**AGENDA
FARRAGUT MUNICIPAL PLANNING COMMISSION**

**August 16, 2018
7:00 p.m. Farragut Town Hall**

**MINUTES
FARRAGUT MUNICIPAL PLANNING COMMISSION**

SUBJECT: Discussion and public hearing on an amendment to the site plan for the Knoxville-Farragut Storage, LLC, 11775 Snyder Road, 6 Acres, Zoned C-2 (Knoxville-Farragut Storage, LLC, Applicant)

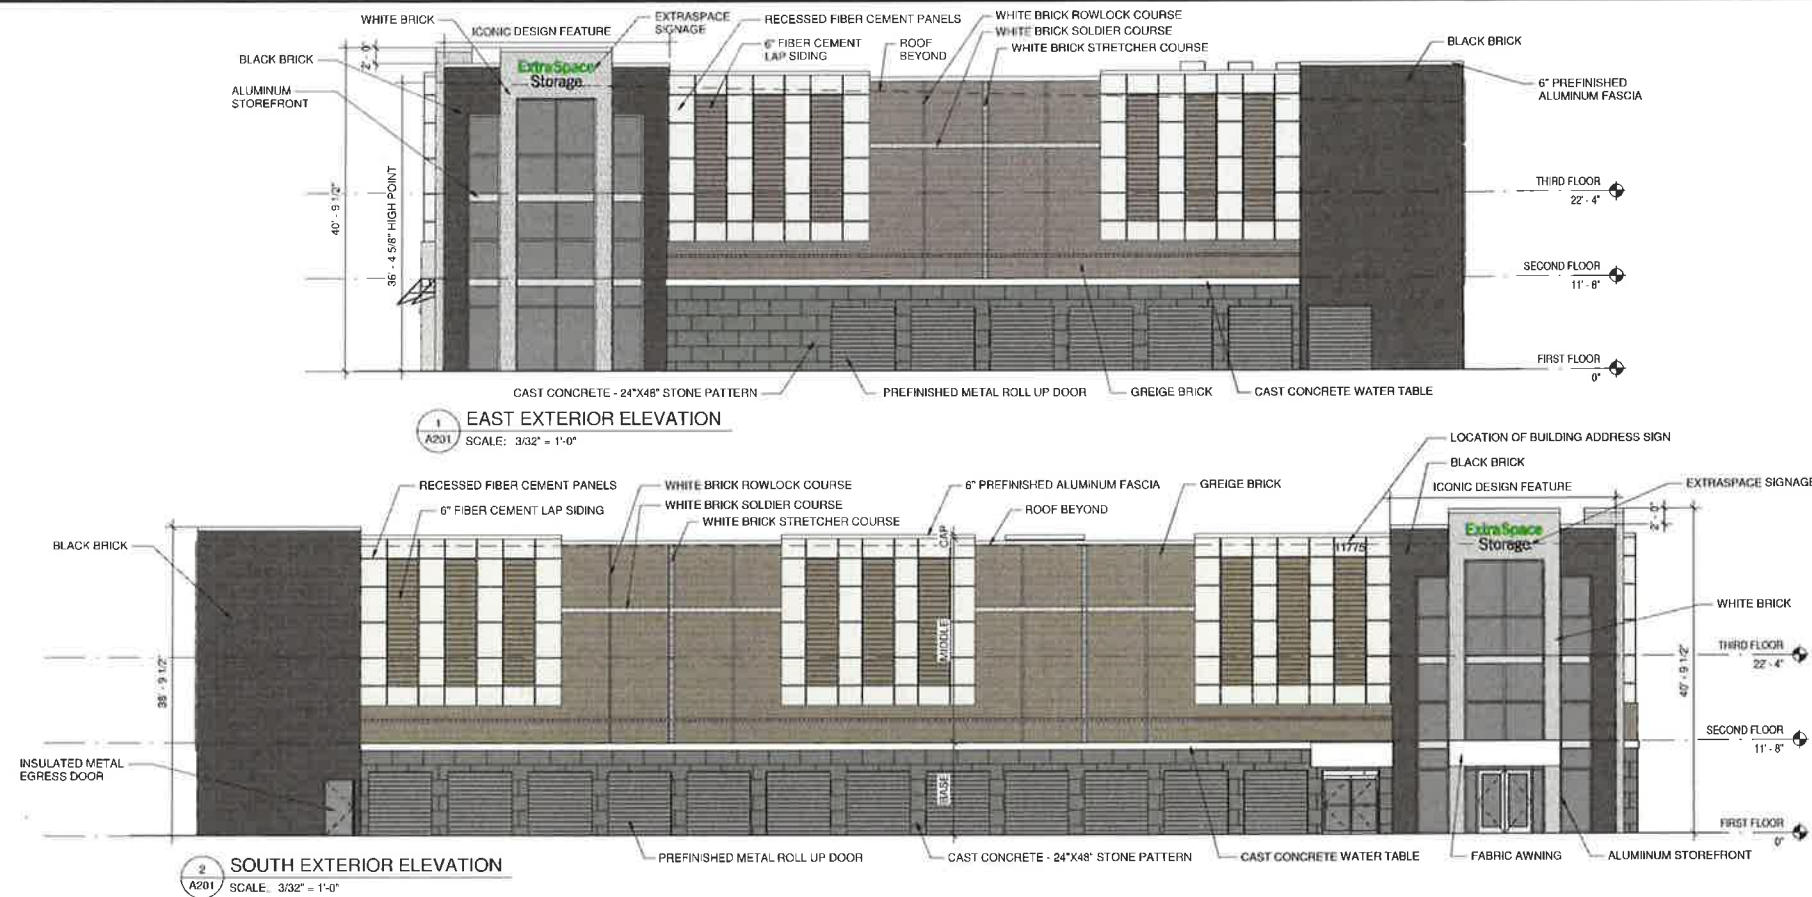
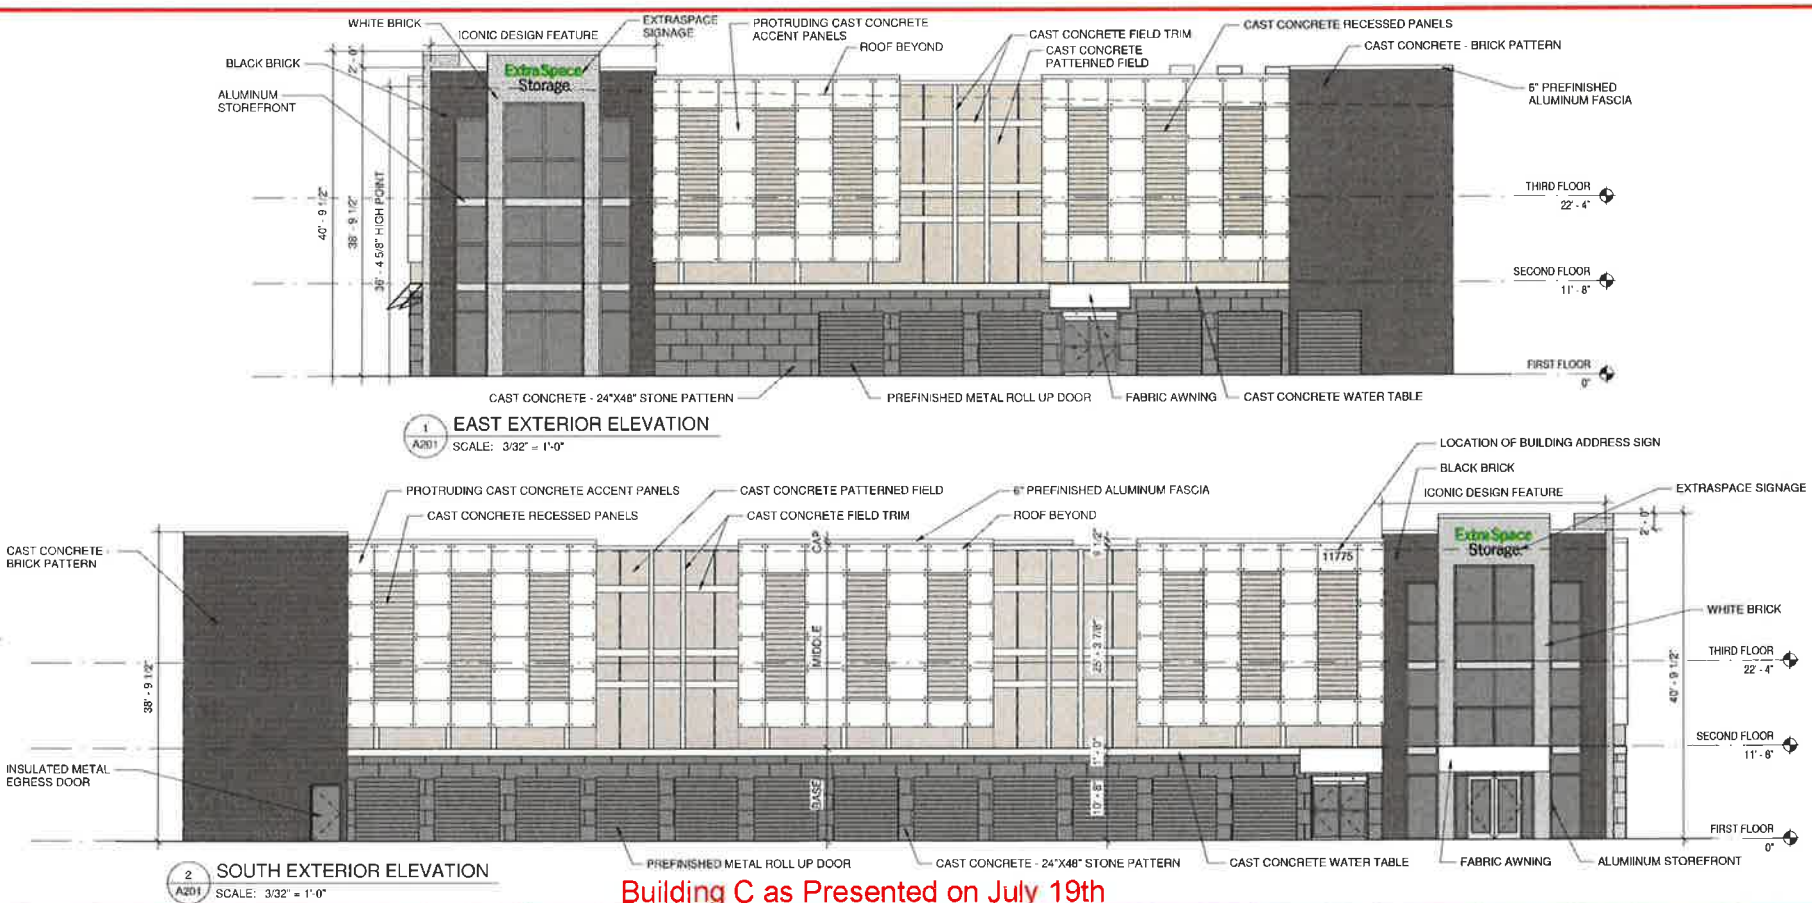
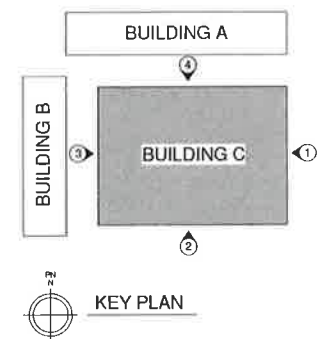
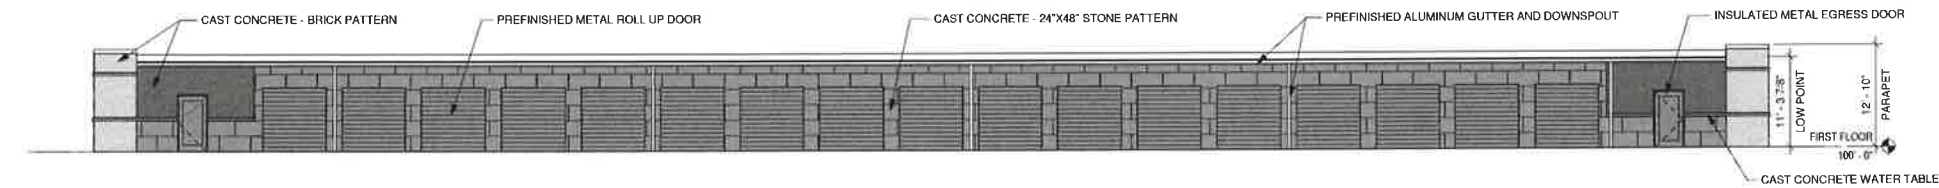
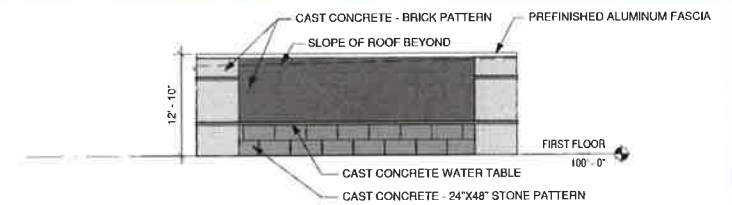
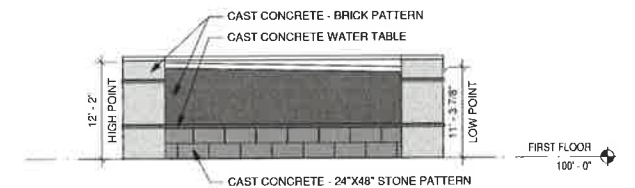
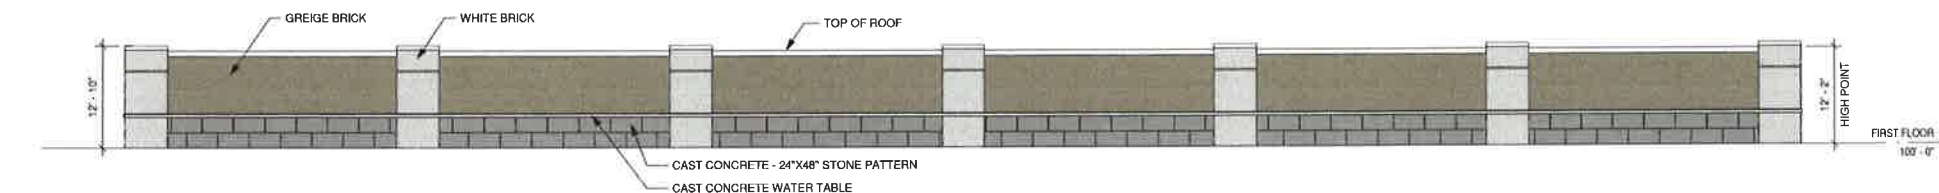
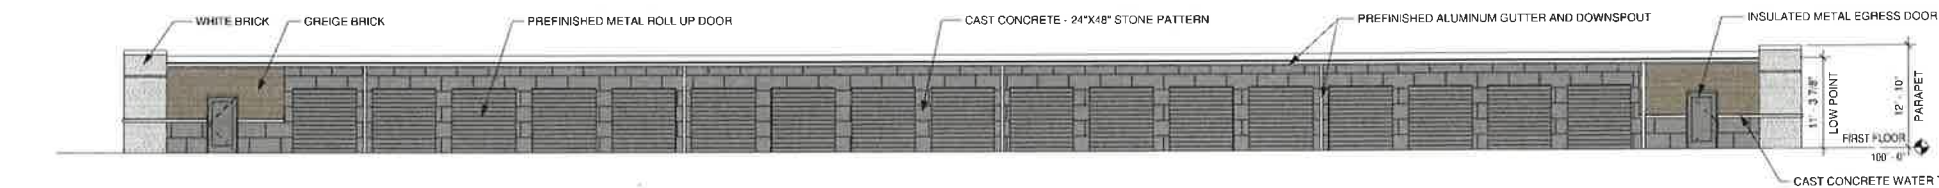
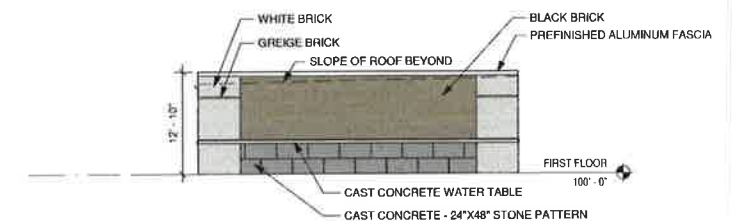
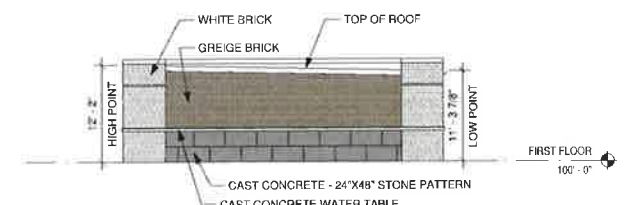
DISCUSSION: One of the staffs' comments concerning the site plan was that some of the materials and the scale and arrangement of the materials would not qualify as masonry as provided for in the Architectural Design Standards. During the discussion, Planning Commissioners generally agreed and asked the applicant to re-visit some portions of the buildings to ensure that the 75% masonry requirement would clearly be satisfied. Commissioners asked that this aspect of the site plan be re-submitted for Planning Commission approval. A key issue with some of the applicant's materials was that concrete proposed to satisfy masonry requirements was not detailed in modules that would resemble traditional masonry panels.

Pg. 46	2.16	Use compatible materials to enhance community image.	Cast concrete is proposed to resemble traditional masonry panels per the definition of masonry provided on page 47.
Pg. 47	2.17	Use masonry materials to promote a cohesive community image.	"Masonry includes brick, stone, or other material requiring mortar, as well as concrete that has been detailed to resemble traditional masonry panels" (Pg. 47). "Concrete that has been detailed in modules similar in scale to genuine brick or stone is an appropriate primary facade material" (Pg. 49). Masonry is shown as the primary building materials along 75% of the facade.
